TECHNICAL REPORT

Cargo Movement Operations System (CMOS)

Review of Software Requirements
Specification (Revised Preliminary)

8 November 1989

ATTACHMENT ONE. BALANCED DATA FLOW DIAGRAM EXAMPLE

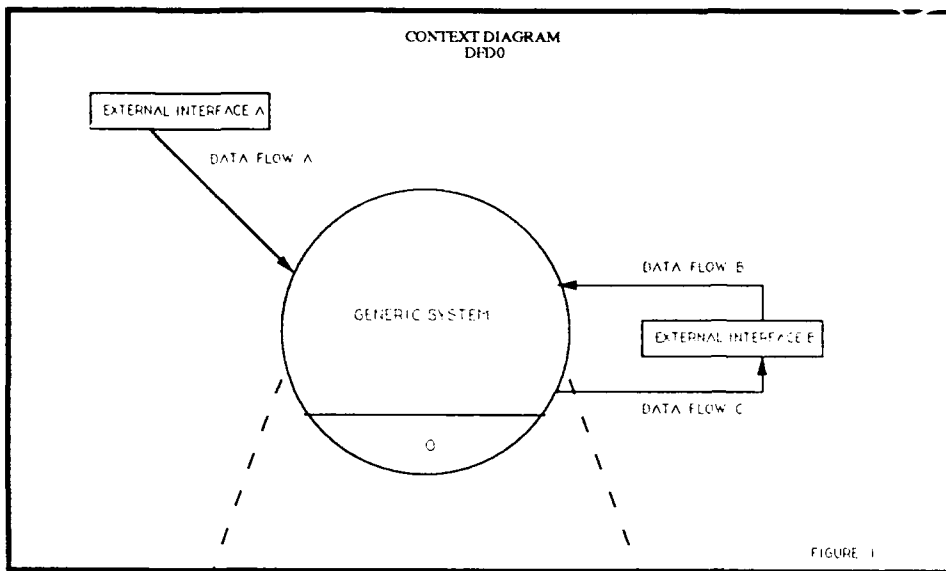
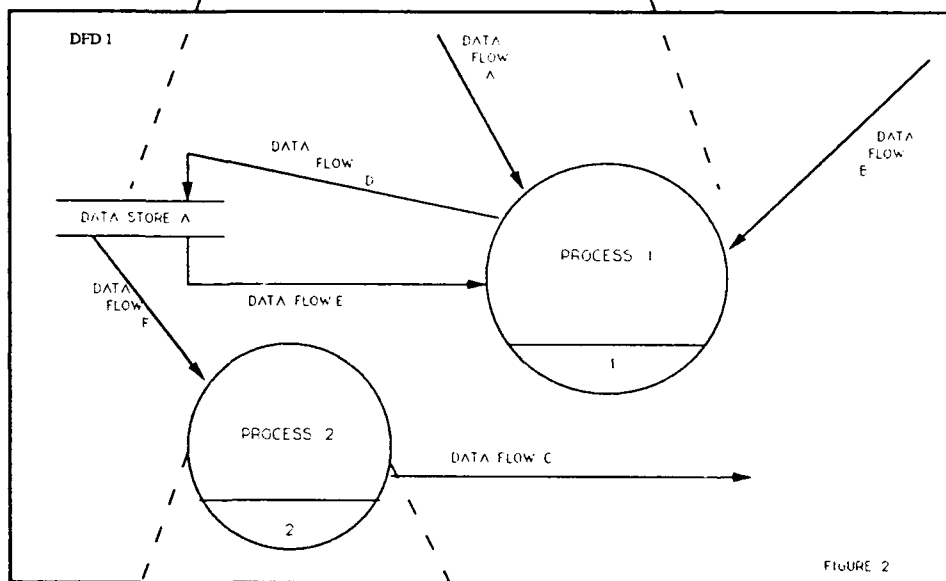
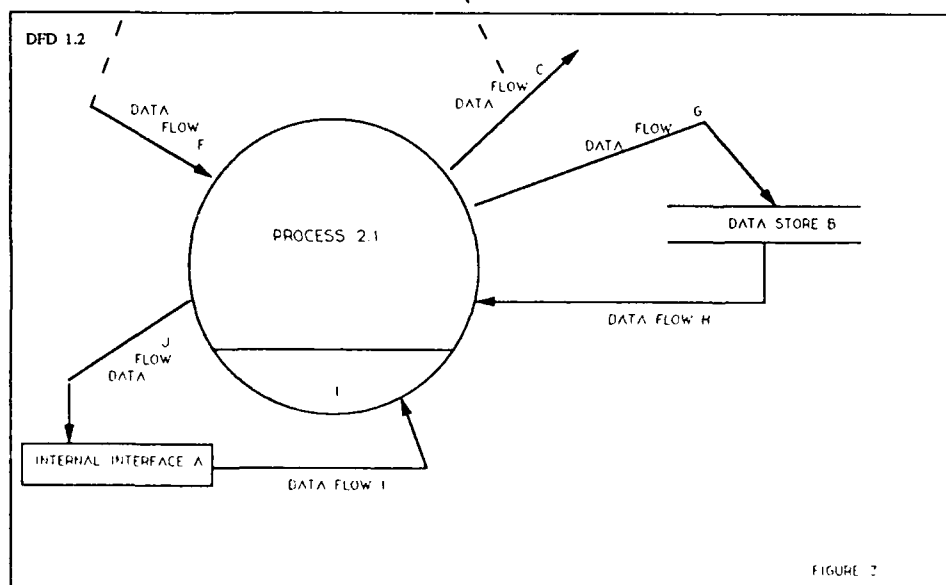
COMMENT OR RECOMMENDED CHANGE: Each external interface should be identified in a rectangle with the associated inputs and outputs. The relationship should be depicted first in a single circular blow-up of CMOS represented as DFD 0. Each system capability (SC) beginning with System Administration and its associated data flows and data stores, should be rendered in DFDs that are numbered 1., 1.1, 1.2, 1.3, etc. The context diagram at Attachment One is provided as an example.

DFD 1 does not logically decompose into DFD 1.1 and the subsequent diagrams, because the standard DFD conventions have not been used. Tracing the allocated requirements through the DFD's is a difficult task due to their disjointed presentation.

The following comment which was submitted during review of the SSDD (figure E-5 on page E-5) also applies to this Data Flow Diagram (DFD). Data flows into and out of a process should balance with the flows of that process. For example, in figure 3.2.1.1, the process "Initialize CMOS" has one inflow and two outflows. Therefore, Figure 3.2.1.1.1 should have two outflows and one inflow. All other flows should begin and end within figure 3.2.1.1 (in a circular fashion). It appears that underlying processes are not represented. Each process should be balanced with its respective exploded view. As all the requirements become allocated to the lower level capabilities, it becomes increasingly difficult to view the processes in the DFDs as anything more than separate, self-contained entities. This comment applies to all DFDs in the Applications CSCI. Please reference Attachment One.
